**ADDENDUM NO. 1  
TO THE BID DOCUMENTS**

**Project:** Homer Harbormaster's Building / DWD Trail Boardwalk  
**Addendum Issue Date:** June 6, 2014  
**Bid Date:** June 19, 2014 @ 2:00PM (Thursday)  
**Previous Addenda Issued:** None  
**Issued By:** Dan Nelsen  
Public Works Project Manager  
City of Homer  
Homer, AK 99603  
[dnelsen@ci.homer.ak.us](mailto:dnelsen@ci.homer.ak.us)

**ELEVATIONS**

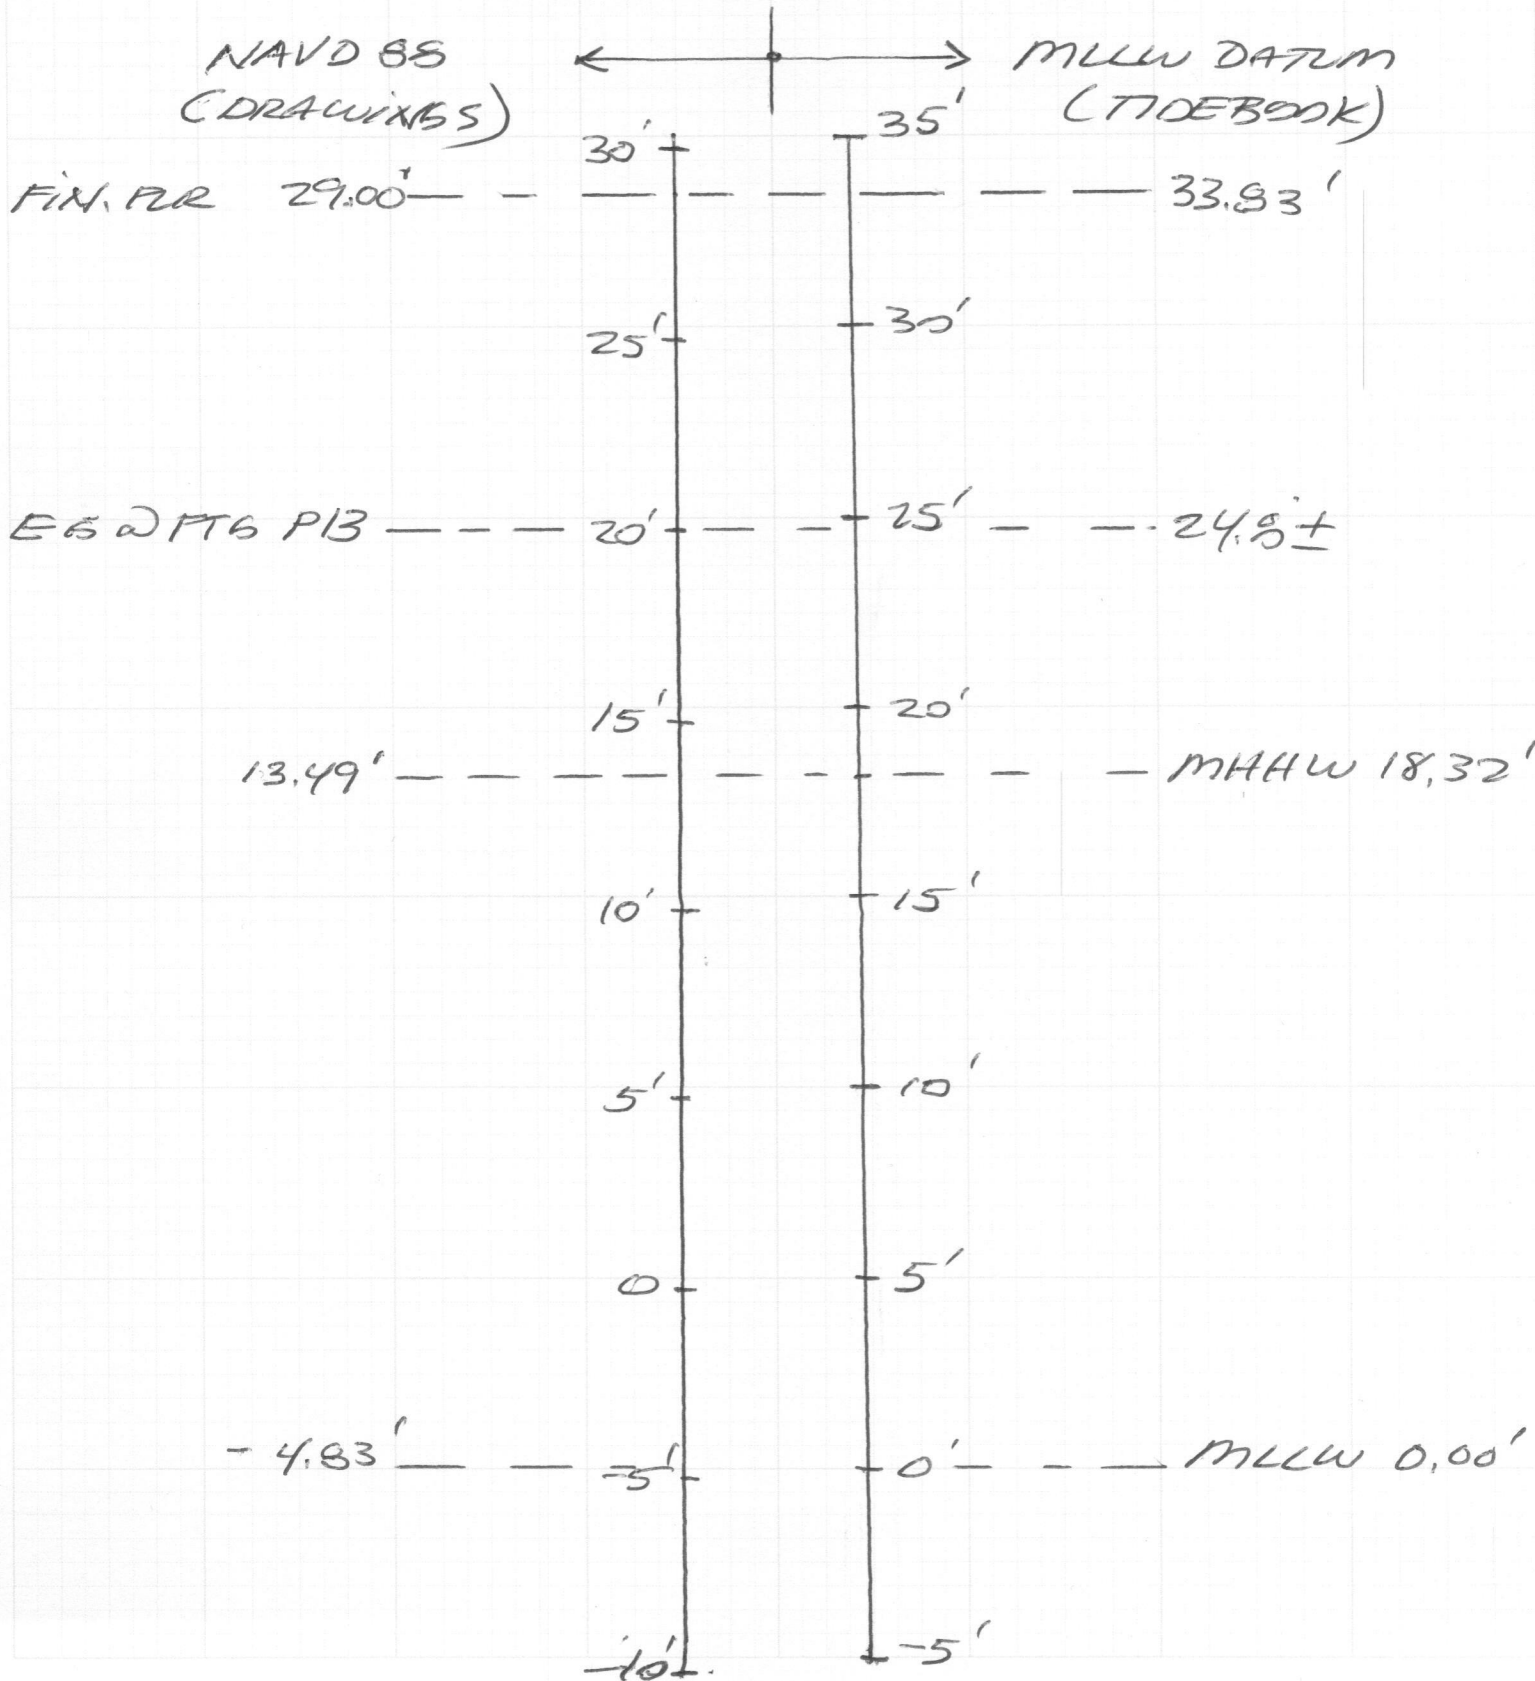
**Is the city aware of the fact that the elevation notations on the civil prints are actually 4.8 feet lower than the foot measurement used to determine tide height?**

*Answer: Yes. This is noted on sheet VI.0, Note 1. Also see attached graphs of the Engineers elevation study for further clarification of this issue.*
